Figure 5

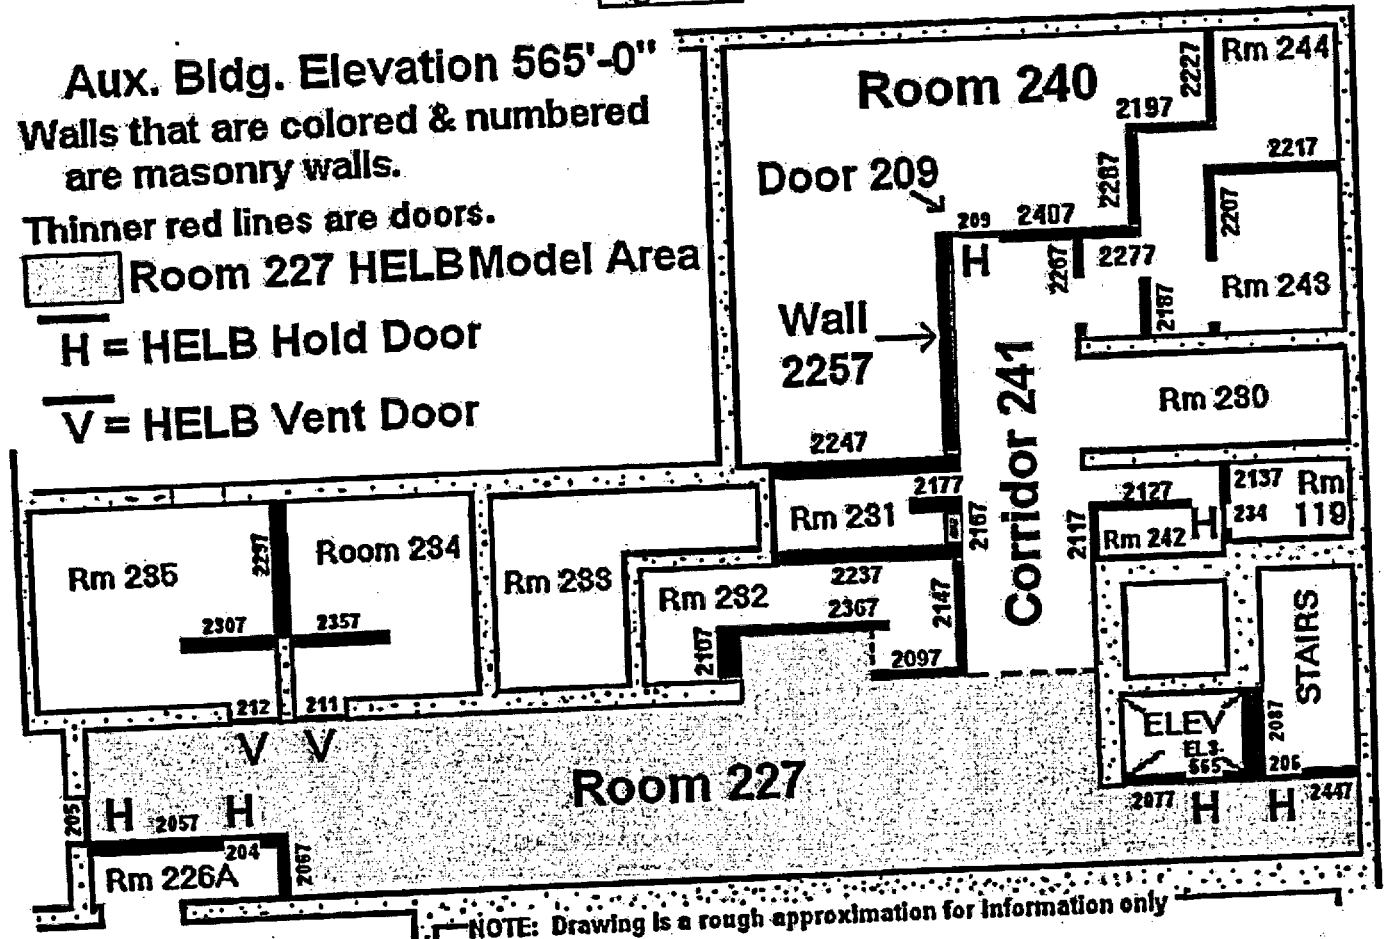
As noted above, wall 2257, which forms one boundary between the Boric Acid Addition Tanks room 240 and corridor 241, would be subjected to compartment pressurization upon a HELB within adjoining room 227. According to C-NSA-000.02-004, corridor 241 is not included with the HELB model for room 227. An artificial "barrier" is indicated by a dotted line in the representation of the HELB area on page 15 of the calculation. The area that C-NSA-000.02-004 modeled as the Room 227 HELB area is represented by the yellow area in Fig. 5 below.

The drawing in Calculation C-NSA-000.02-004 of the Room 227 HELB area shows the border of the area with a solid line, not distinguishing between concrete walls, masonry walls and solid doors.¹⁷ As noted above, the opening to Corridor 241 and the doorway to Room 232 were shown as dotted lines indicating borders without barriers.
